February 21, 2020

RE: Prime Plattsburgh Development – 2.10.20 Public Hearing Comment Responses

PUBLIC COMMENT RESPONSES

Examples of Existing Waterfront Walkways in Urban Setting

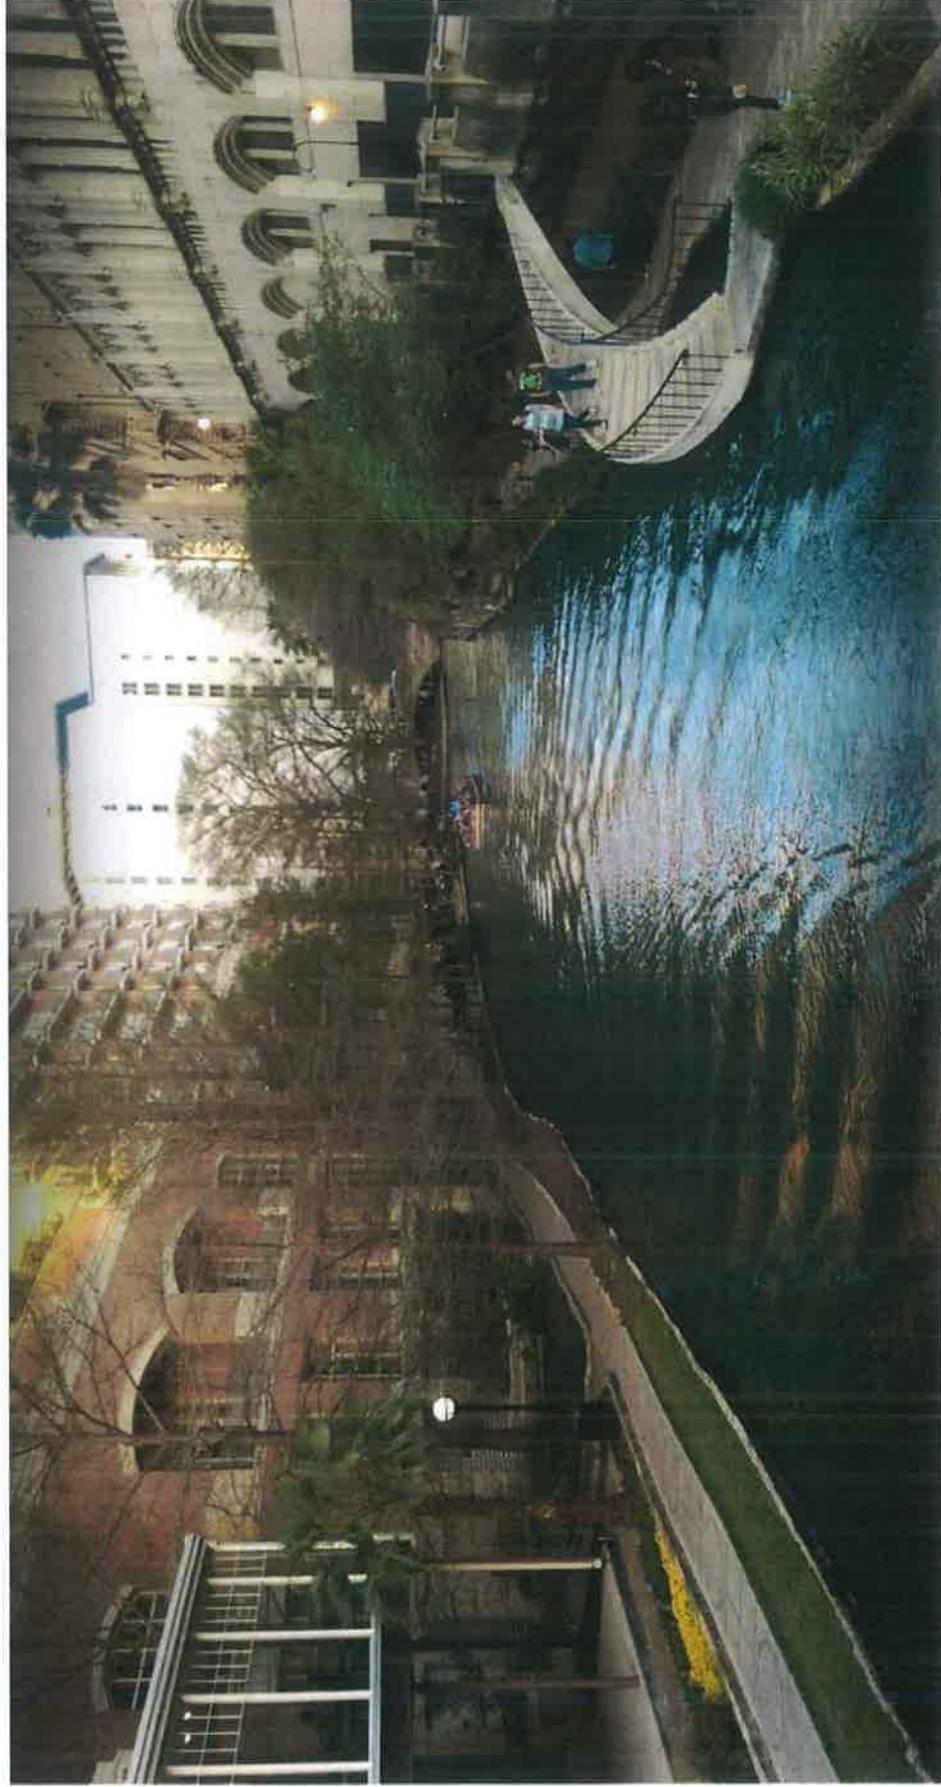
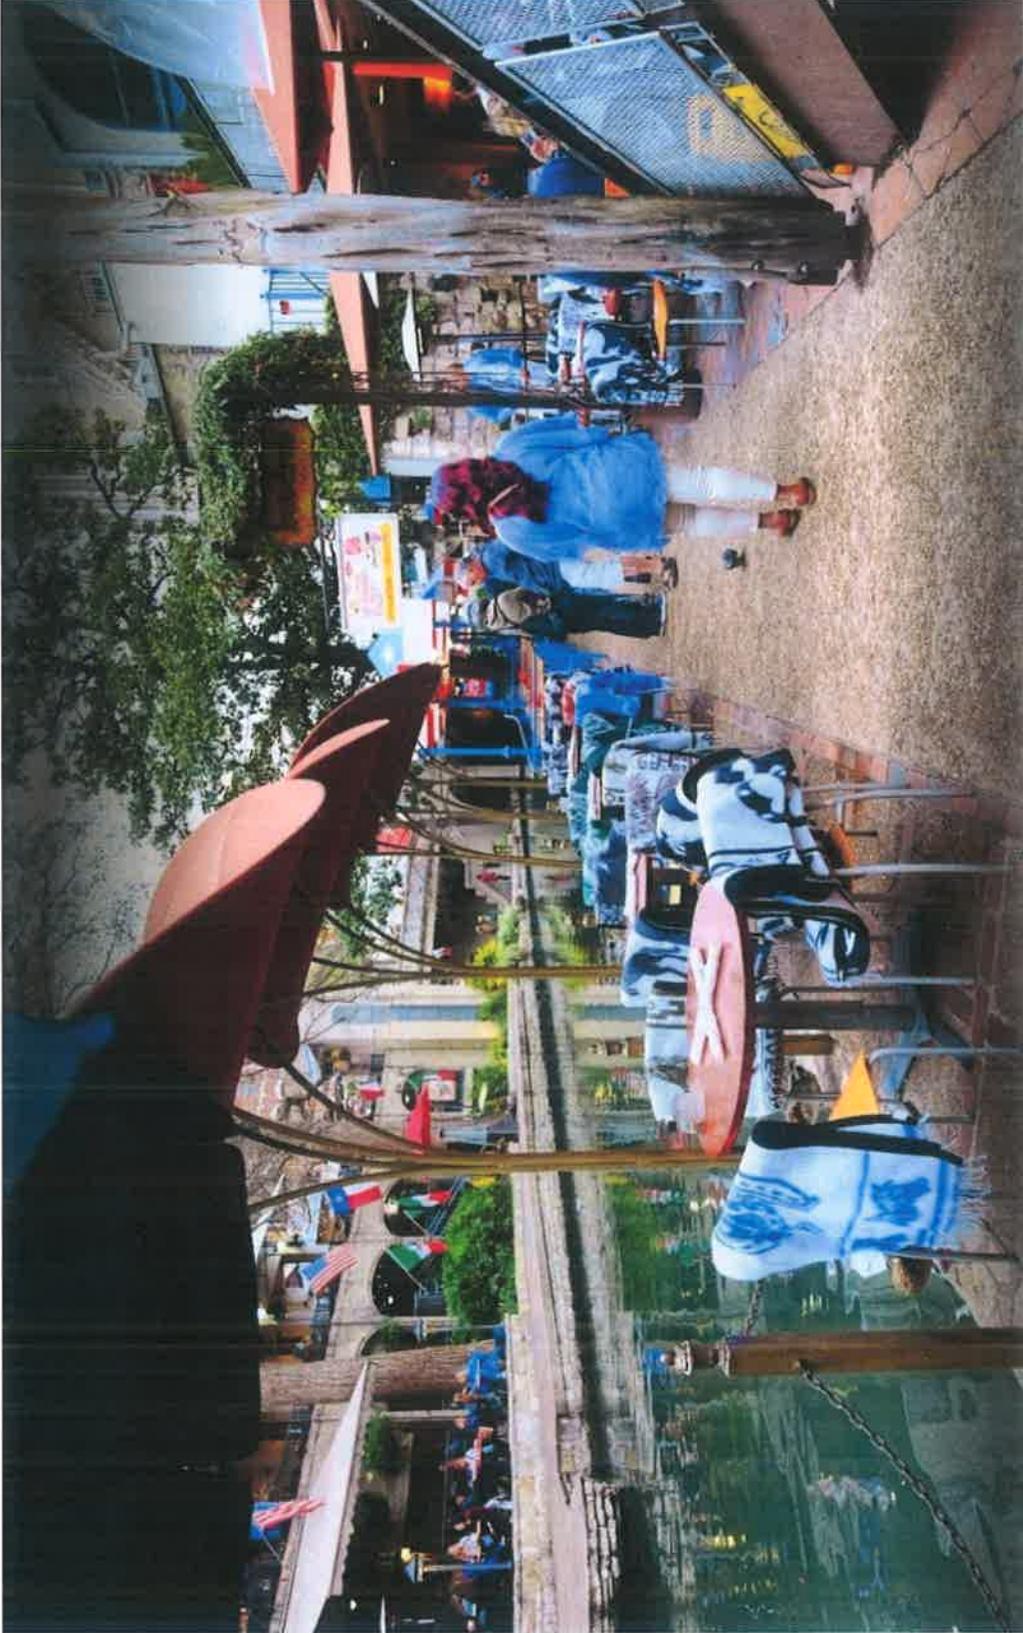
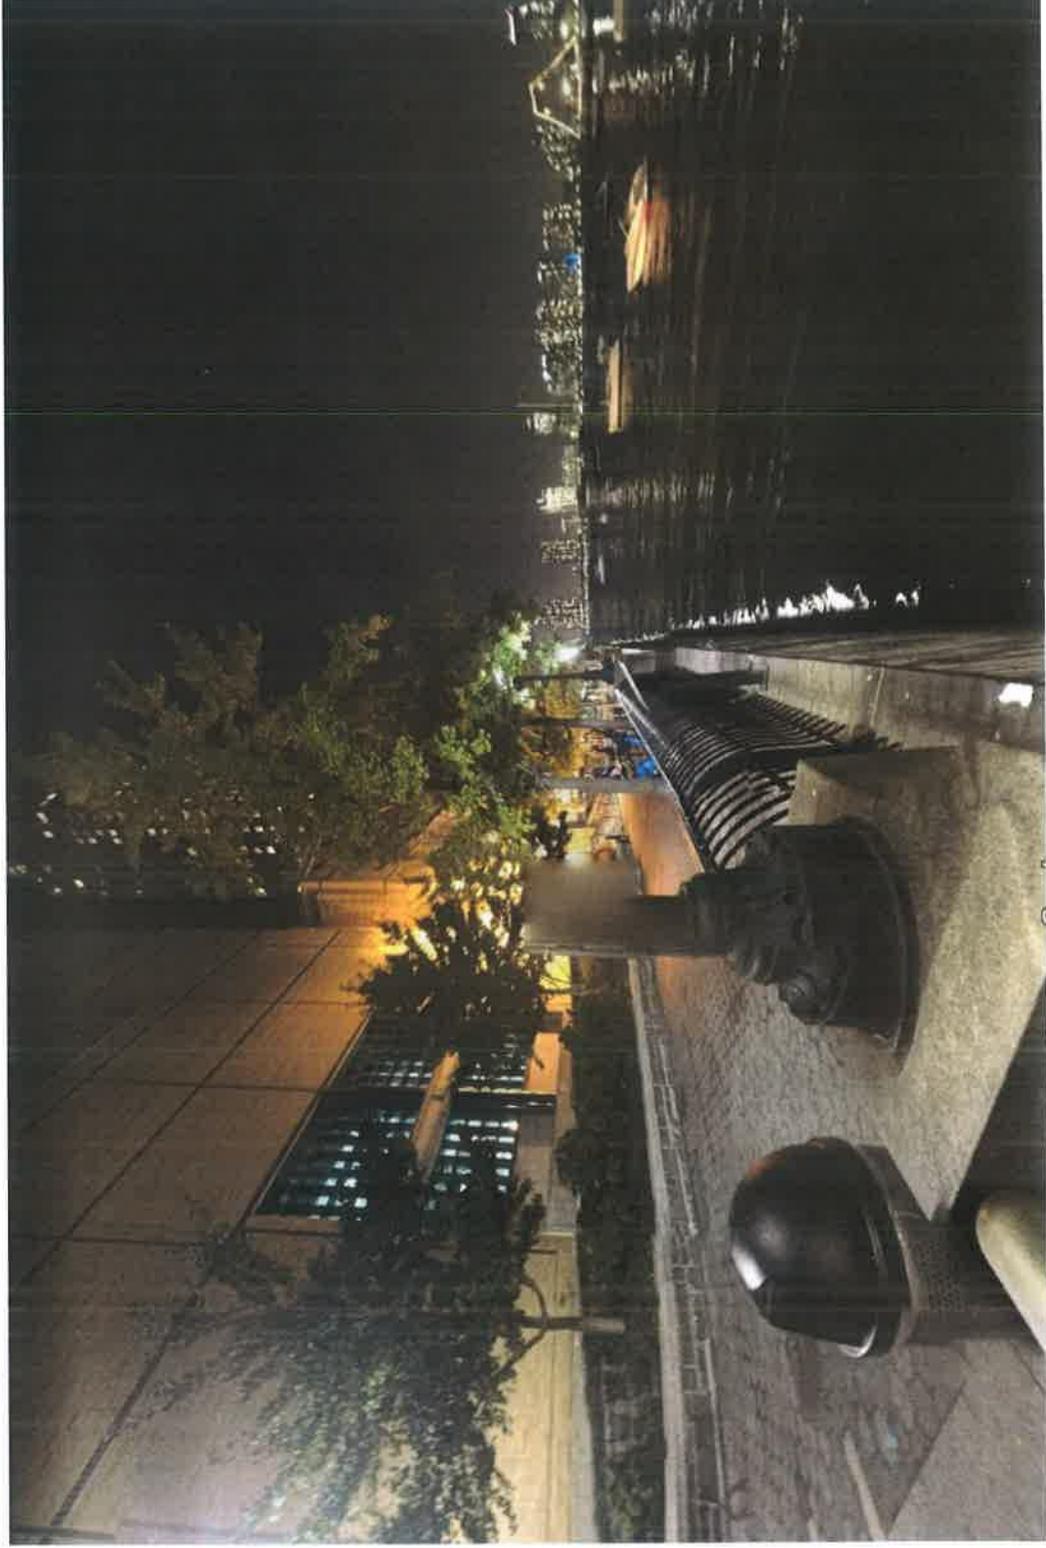
Comment #42: *The Project violates the public health and safety because of the narrow Riverwalk, which is being referred to as "danger alley".*

Response #42: The closest point of the proposed building to the top of the bank is about 25' (just south of Bridge Street), with approximately 30' from the top of the bank to the shoreline. For comparison, the existing Farmer's Market structure is about 20' from the top of the bank.

The Riverwalk design includes a few trees, which are typically limbed up to facilitate pedestrian walkability and open sight lines, to be located at the open space on the east side of the proposed building, at the overlook, and along the current farmer's market structure. The majority of the other plantings will be low-growing species of shrubs and perennials, in order to soften the building edges and maintain visibility over and around any planted areas. The remediation work NYSEG will be conducting for the Saranac River may also result in the removal of existing trees along the bank, which may be replaced by lower-growing vegetation to maintain slope stability. This will further open sightlines, increase the amount of daylight, and expand views to the water. Additionally, the design for the Riverwalk includes pedestrian-scale lighting along the full length of the walkway to improve safety during evening hours.

Please see attached images of various examples of existing waterfront walkways in close proximity to buildings, such as San Antonio Riverwalk, Battery Park Esplanade in NYC, and the Onondaga Creekwalk in Syracuse. Exhibit C.

PROPOSED DRI 114 UNIT RESIDENTIAL HOUSING COMPLEX
WEST ELEVATION

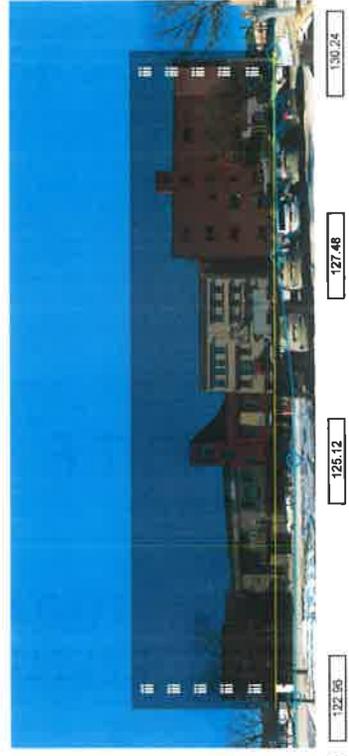
Comment #39: *The massing of the building is too large. The ZBA has not seen finished floor elevations nor a complete inventory of surrounding building heights. The commenter presented a rendering of the scale of the proposed building. Building will be essentially 7 stories at the southern end of Durkee Street due to elevation drop. Visual rendering purporting to show proposed building silhouette compared to existing structures.*

We must clarify the inaccuracy of the visual rendering submitted by those opposing the Project, which purports to show the building silhouette compared to existing structures. This rendering was presented to the ZBA by a member of the opposition and was not submitted at the public hearing for the record. Weeks later, a PDF copy of the opposition's rendering was submitted to the ZBA. We have annexed hereto as Exhibit F a picture of the rendering presented at the public hearing but not submitted for the record at the public hearing (screen shot from the public hearing video) as well as the PDF of this opposition rendering submitted to the ZBA weeks later (collectively the "Opposition's Illustrations"). See Exhibit F. This demonstrates the deception that was utilized by the opposition in first presenting a rendering that is a grossly inaccurate portrayal of the building height, and then later submitting a scaled down version, realizing it would be reviewed by the Applicant and Prime's consultants. Thus, this information submitted by the opposition, which to our knowledge was not prepared by a professional architect and was provided without any explanation of how it was created, cannot be relied upon by the ZBA.

Because the opposition never gave any explanation as to the technique used for its creation of the Opposition Illustrations, we cannot comment on the same. However, Prime's Project Architect has determined the Opposition's Illustrations are inaccurate and has provided a accurate depiction of the building height as compared to other buildings in the area of the Project Site. See Exhibit D.
